re: Superseding of Application #301930560
26 Remsen St, Brooklyn, NY (BIN#302119)

26 REMSEN ST.

DOB REPORT

PROPOSED PLANS: SECOND FLOOR

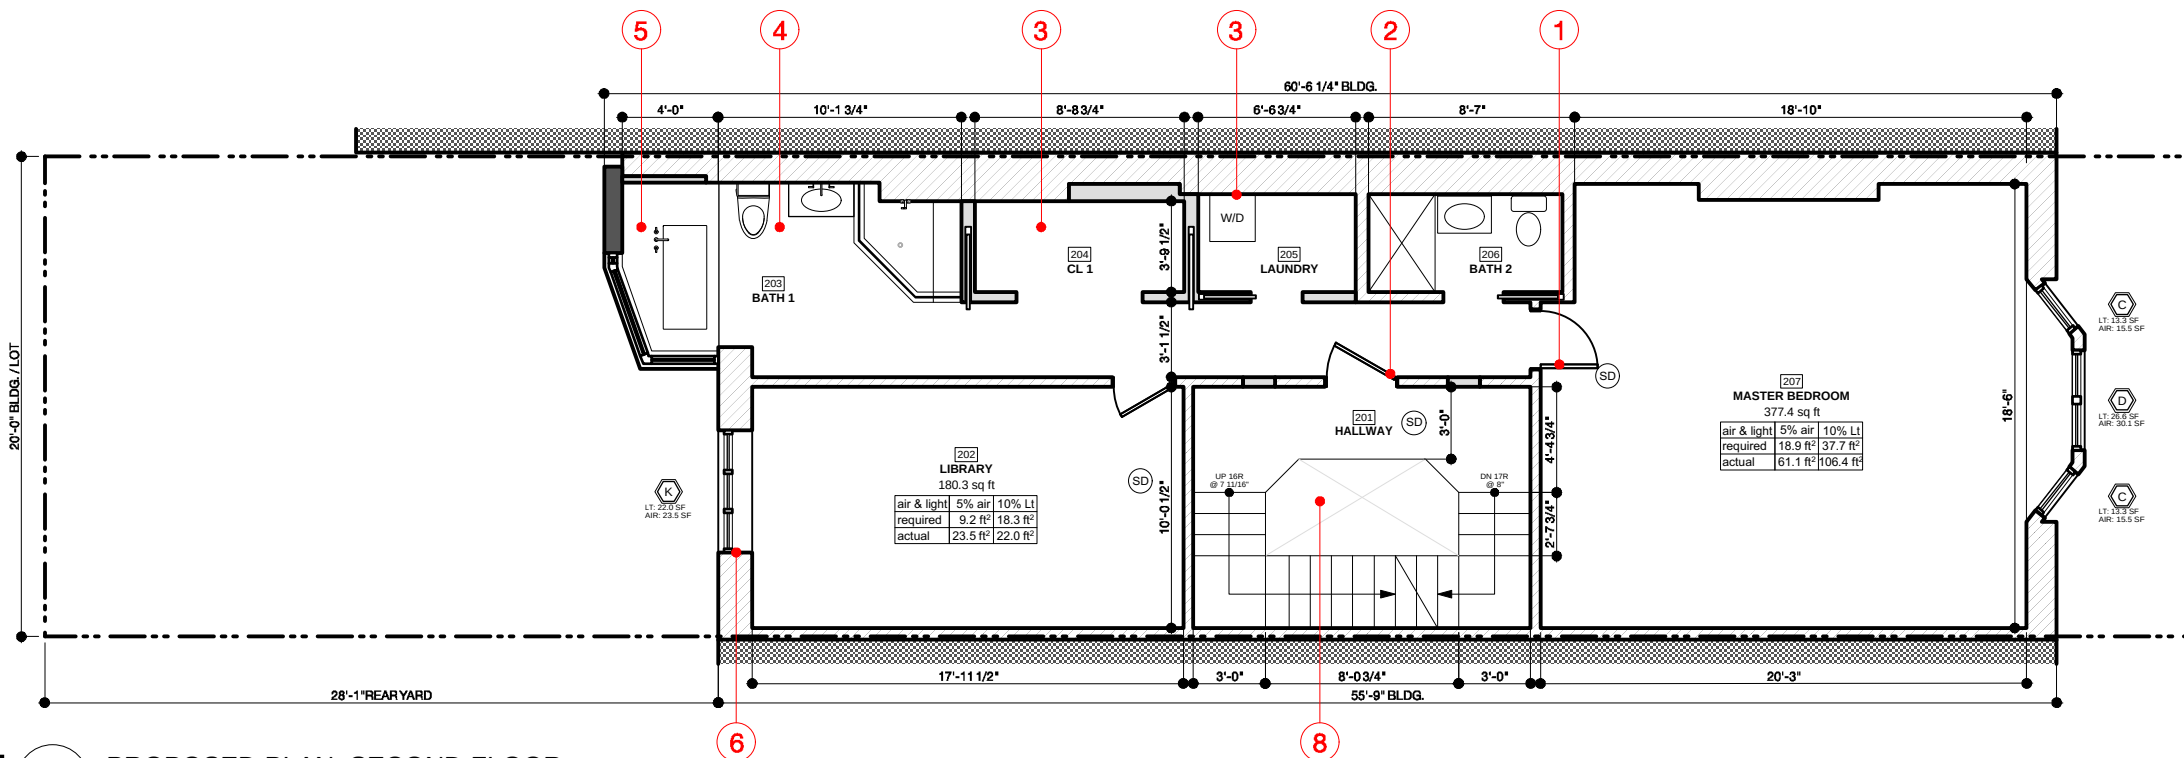
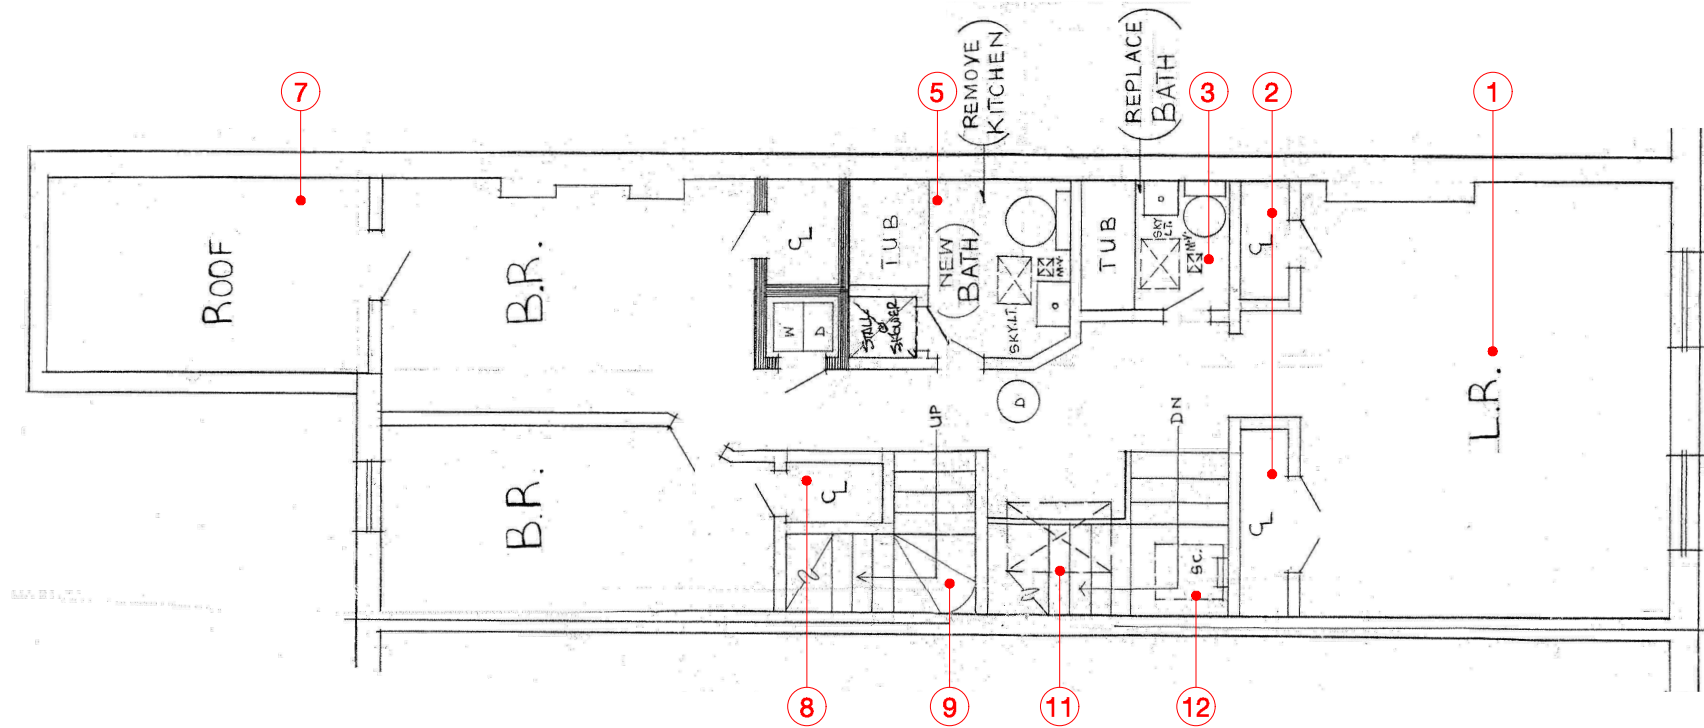
1. DOOR LOCATION TO MASTER BEDROOM IN PROPOSED.
2. DOOR ADDED TO WEST WALL OF HALLWAY TO MASTER SUITE IN PROPOSED.
3. LOCATION OF CLOSET & LAUNDRY SWITCHED IN PROPOSED. SIZE OF EACH SPACE ALSO ADJUSTED IN PROPOSED.
4. SIZE & CONFIGURATION OF MASTER BATHROOM CHANGED IN RELATION TO CHANGE OF REAR EXTENSION IN PROPOSED.
5. REAR EXTENSION SIZE, LAYOUT & USE CHANGED IN PROPOSED.
6. REAR FACADE WINDOW CONFIGURATION CORRECTED TO MATCH EXISTING IN PROPOSED.
7. DOOR FROM HALLWAY TO LIBRARY NOT IN PROPOSED.
8. OPENING TO BELOW AT HALLWAY/STAIRS CORRECTED TO MATCH EXISTING SHAPE & SIZE IN PROPOSED.

PROPOSED PLANS: THIRD FLOOR

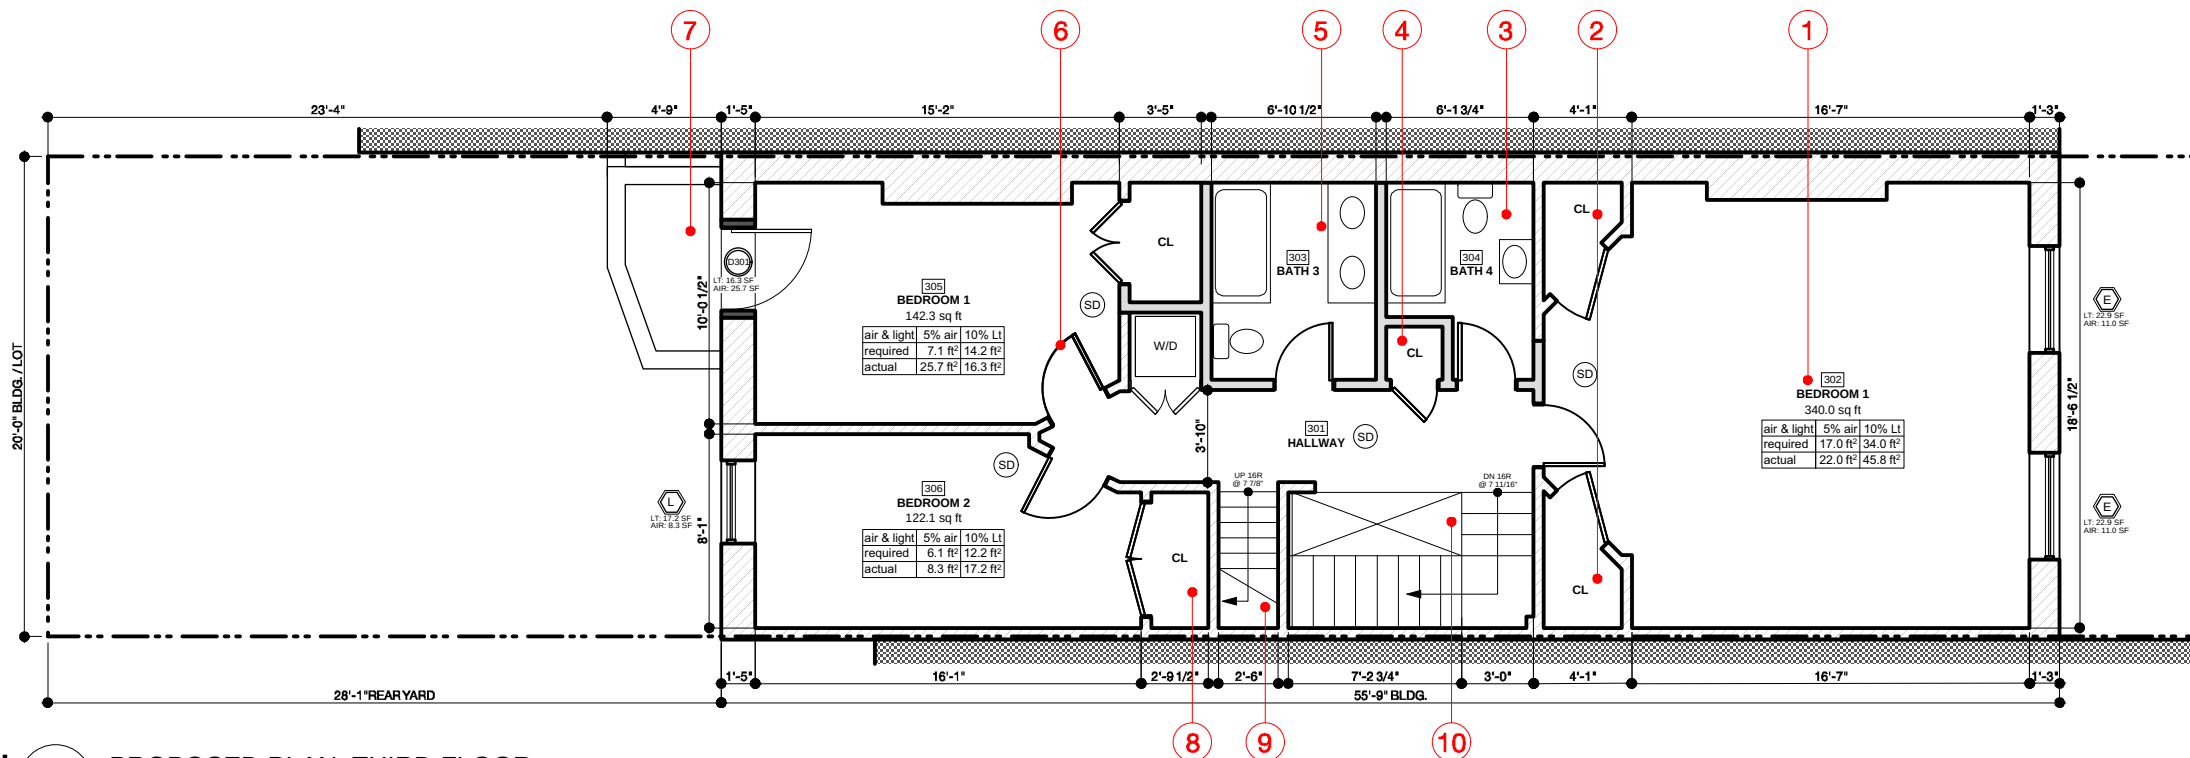
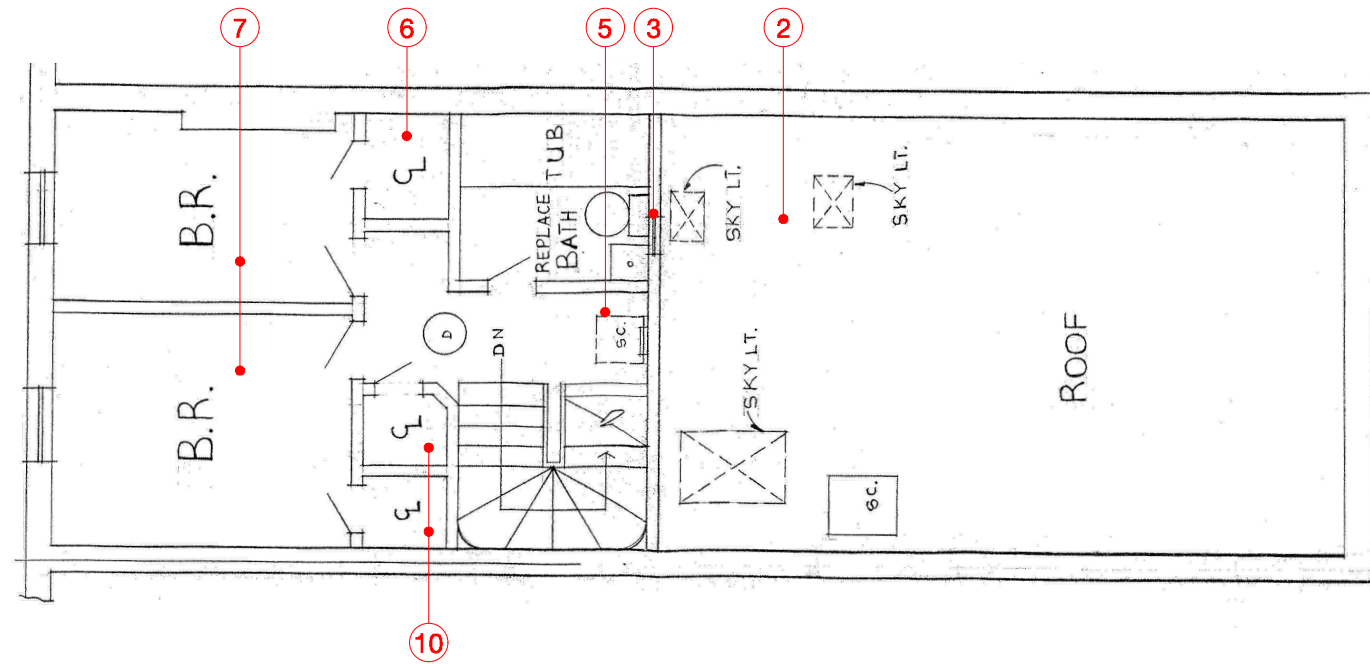
1. LIVING ROOM CHANGED TO BEDROOM IN PROPOSED.
2. CLOSET LAYOUT CORRECTED TO MATCH EXISTING IN PROPOSED.
3. BATH 4 SIZE, LAYOUT & PLUMBING FIXTURE LOCATIONS CHANGED IN PROPOSED.
4. CLOSET ADDED IN PROPOSED.
5. BATH 3 SIZE, LAYOUT & PLUMBING FIXTURE LOCATIONS CHANGED IN PROPOSED. ADDITIONAL LAV ADDED & SHOWER REMOVED IN PROPOSED.
6. EX'G WALL & DOOR TO BEDROOM 1 CORRECTED TO MATCH EXISTING IN PROPOSED.
7. REAR ROOF TERRACE SIZE & LAYOUT CHANGED IN PROPOSED.
8. EX'G CLOSET TO REMAIN IN PROPOSED.
9. STAIR CORRECTED TO MATCH EXISTING IN PROPOSED.
10. OPEN TO BELOW AREA IN HALLWAY/STAIRS CORRECTED TO MATCH EXISTING IN PROPOSED.
11. SKYLIGHT FROM PREVIOUSLY APPROVED NOT IN PROPOSED.
12. SCUTTLE & LADDER TO ROOF IN PREVIOUSLY APPROVED NOT IN PROPOSED.

PROPOSED PLANS: FOURTH FLOOR

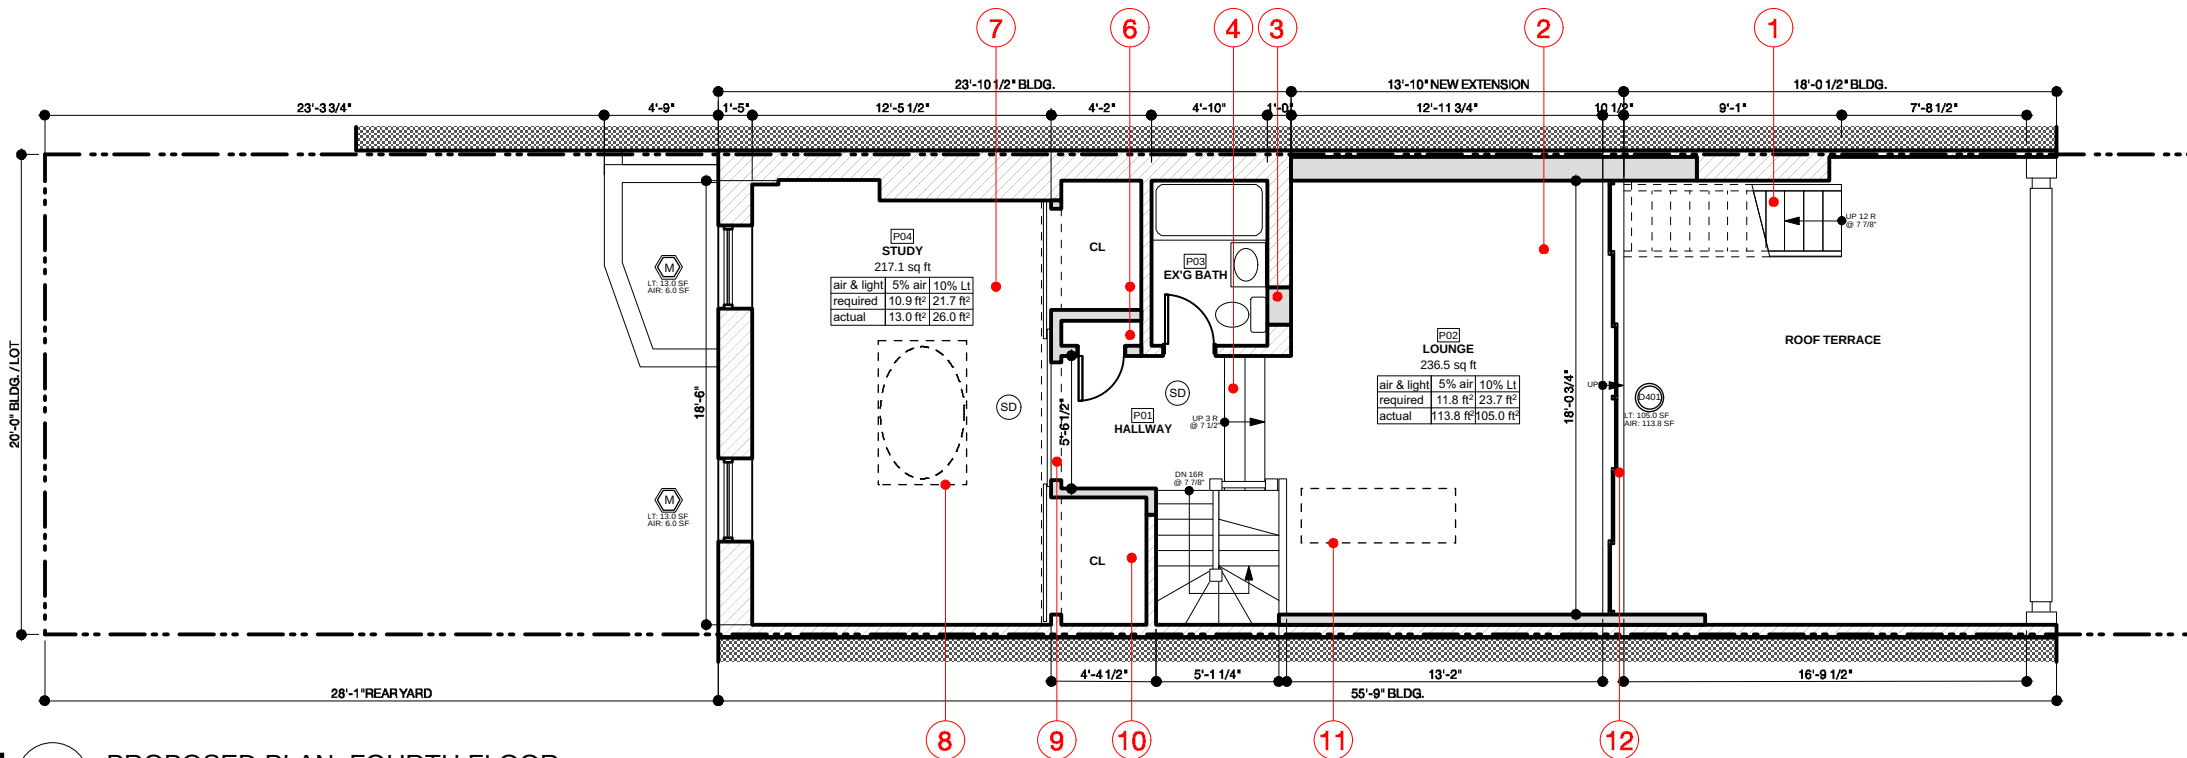
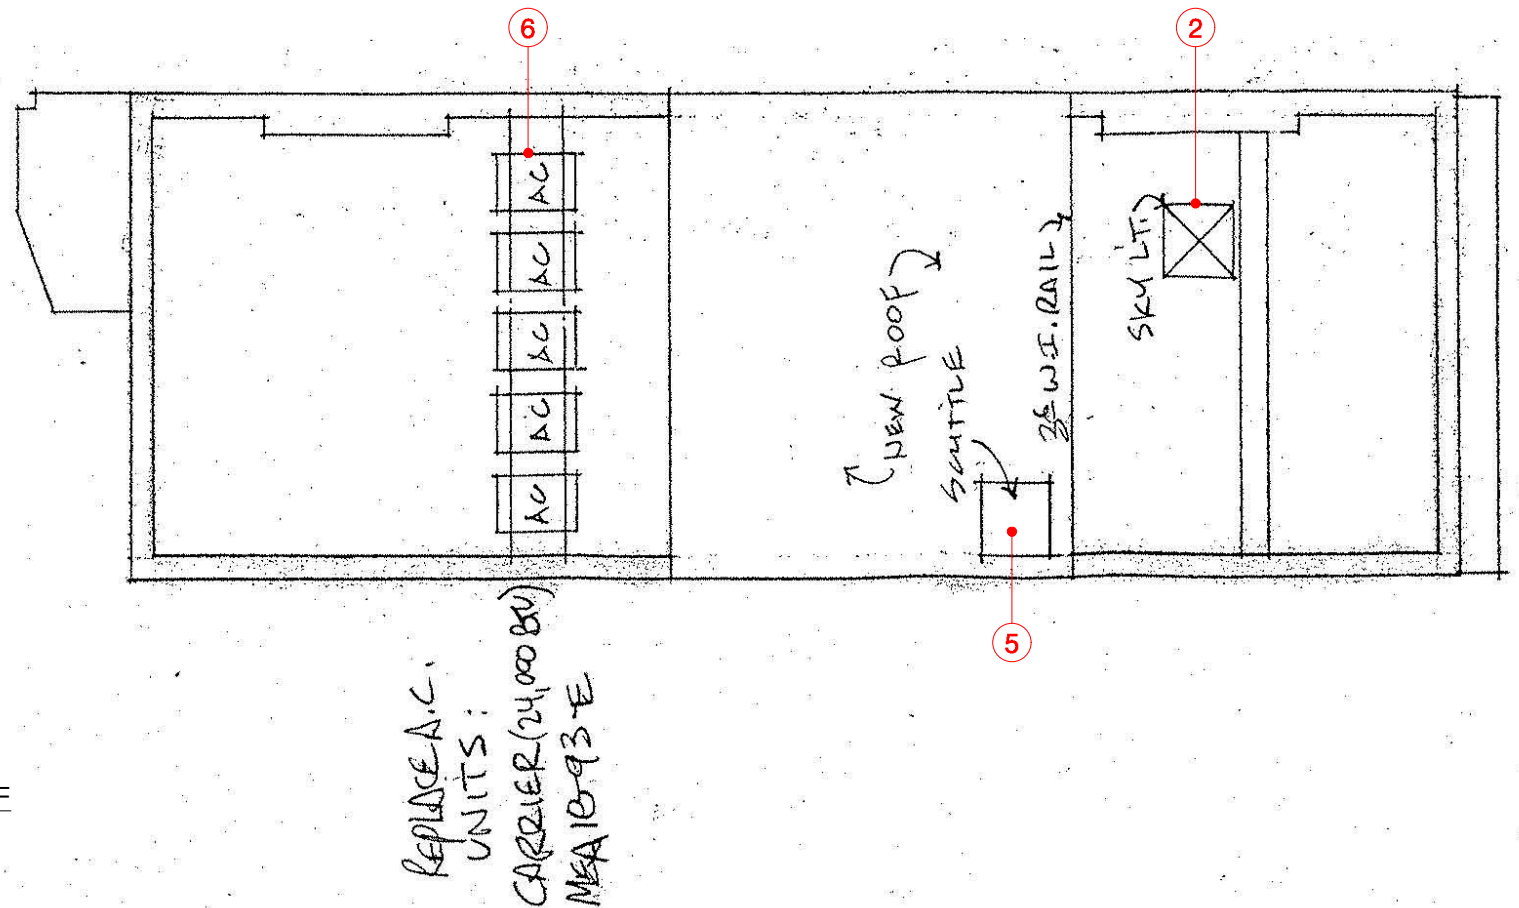
1. STAIRS TO UPPER ROOF IN PROPOSED.
2. FOURTH FLOOR ENLARGED WITH AN ADDITION OF A LOUNGE IN PROPOSED.
3. WINDOW AT BATHROOM REMOVED DUE TO ENLARGEMENT OF FOURTH FLOOR IN PROPOSED.
4. STEPS ADDED AT HALLWAY TO LOUNGE IN PROPOSED.
5. SCUTTLE & LADDER NOT IN PROPOSED.
6. CLOSET QUANTITY & SIZE ENLARGED IN PROPOSED.
7. AREAS OF TWO BEDROOMS IN PREVIOUSLY APPROVED PLAN COMBINED & CHANGED TO STUDY IN PROPOSED.
8. SKYLIGHT ADDED IN PROPOSED.
9. LARGE SINGLE OPENING TO STUDY FROM HALLWAY IN PROPOSED.
10. AREAS OF TWO CLOSETS FROM HALLWAY & BEDROOM IN PREVIOUSLY APPROVED COMBINED TO ONE CLOSET FOR STUDY IN PROPOSED.
11. SKYLIGHT ADDED TO LOUNGE IN PROPOSED.
12. NEW LARGE DOOR OPENING FOR LOUNGE IN PROPOSED.

PROPOSED PLANS: ROOF

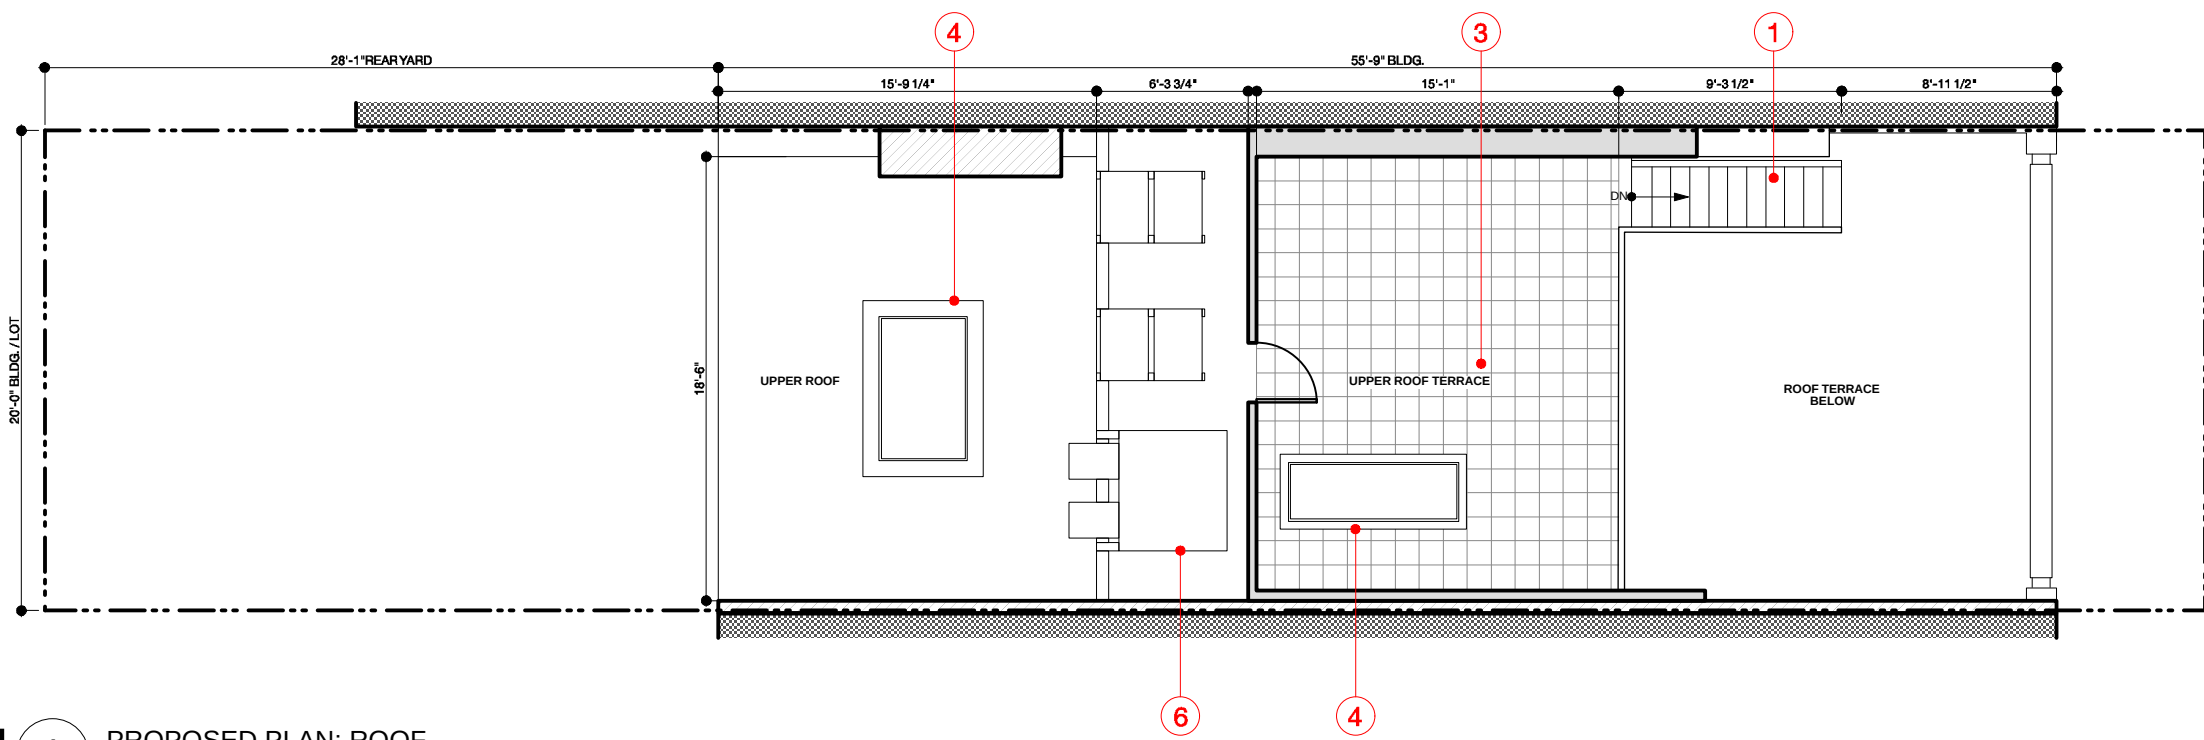
- 1. STAIRS TO UPPER ROOF IN PROPOSED.
- 2. SKYLIGHT IN PREVIOUSLY APPROVED NOT IN PROPOSED.
- 3. UPPER ROOF TERRACE IN PROPOSED.
- 4. SKYLIGHTS IN PROPOSED.
- 5. SCUTTLE IN PREVIOUSLY APPROVED NOT IN PROPOSED.
- 6. MECHANICAL UNITS ON UPPER ROOF LEVEL INSTEAD OF ROOF TERRACE LEVEL IN PROPOSED.
